**GRAND COUNTY**

PR 51  
 (59FR14912)

The Grand County Council appreciates the opportunity to comment on the NOI to prepare an EIS and to conduct a scoping process for reclamation of Atlas Corporation's Uranium Recovery facility near Moab, UT.

Comments pertaining to the proposed NOI outline:

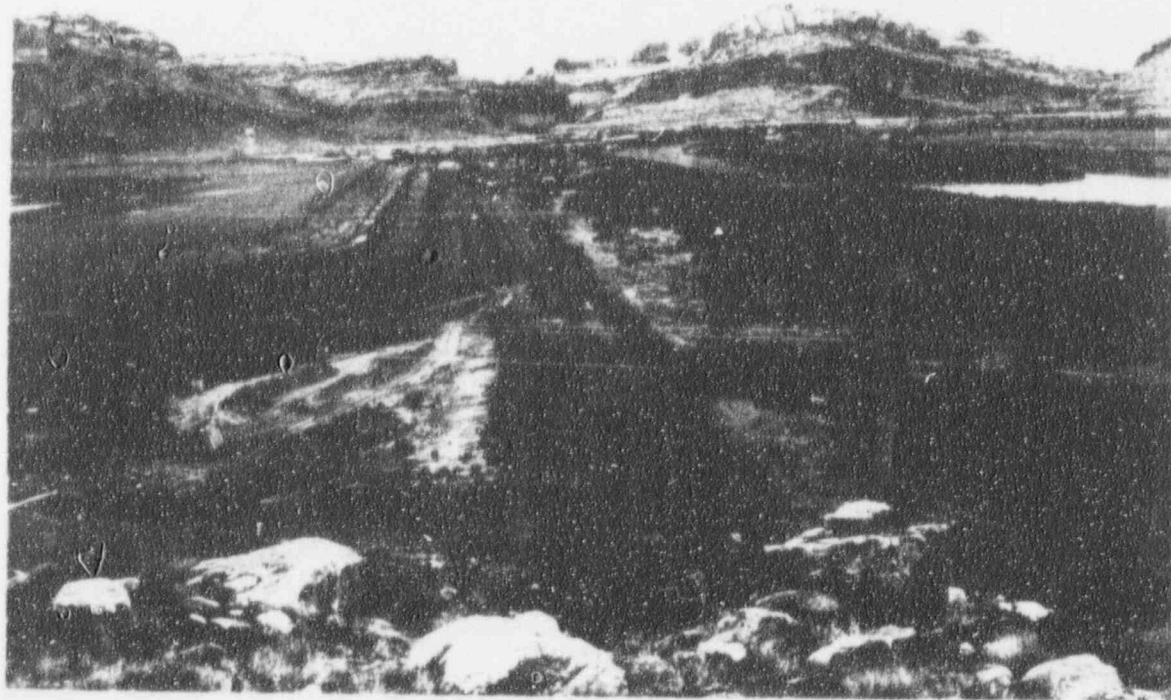
As is illustrated in the accompanying photographs, please determine what has killed the tamarisks and the status of the remaining ecosystem adjacent and down stream to the tailings pursuant to 40 CFR Part 1502.16.

Please explain what has happened to the tamarisks in the accompanying photographs. The original FES in 1979 and subsequent ERS's consistently state that there should be no impacts to the environment, yet any monitoring that was
